Publication No. MA3479-14
04MAY04
Part No. 6F8817

MODIFICATION INSTRUCTIONS for the *Kodak* MINILOADER 2000P Service Code: 3479

Modification No. 14
Type 1 Selective

Purpose: To install a GROUND STRAP to prevent artifacts caused by electrostatic discharge at the ENTRY FILM GUIDE.

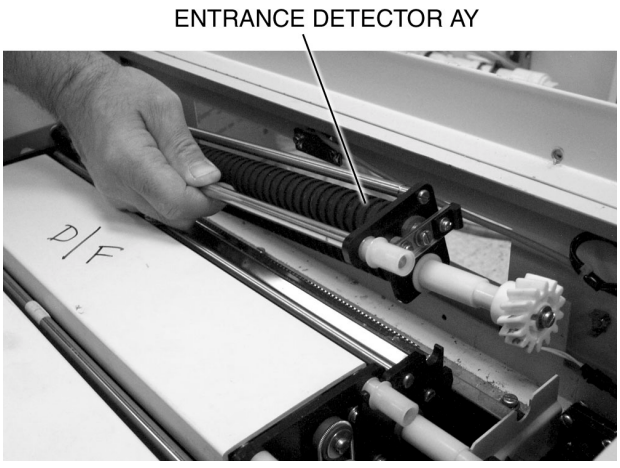
[4] Remove the LIGHT BAFFLE.

[5] Remove the ENTRANCE DETECTOR AY.

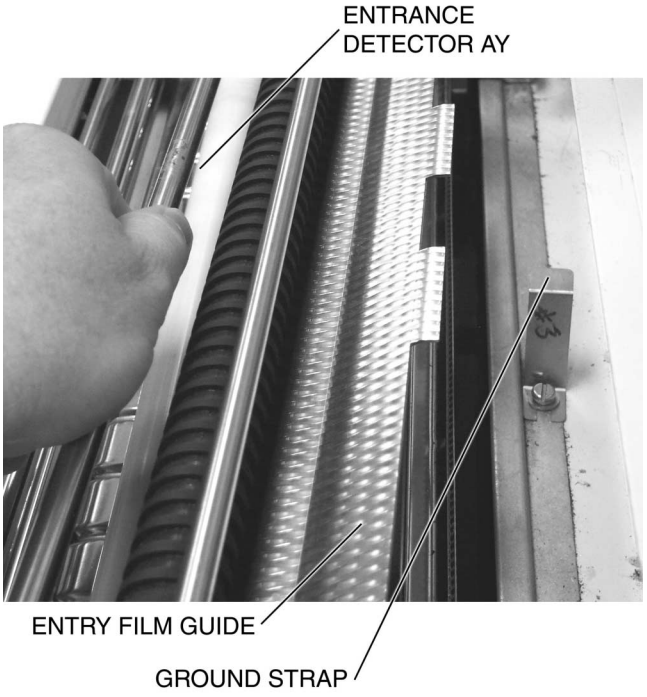
[6] Loosen the SCREW.

[7] Install the GROUND STRAP.

[8] Tighten the SCREW.

[10] Check that the ENTRY FILM GUIDE makes contact with the GROUND STRAP.
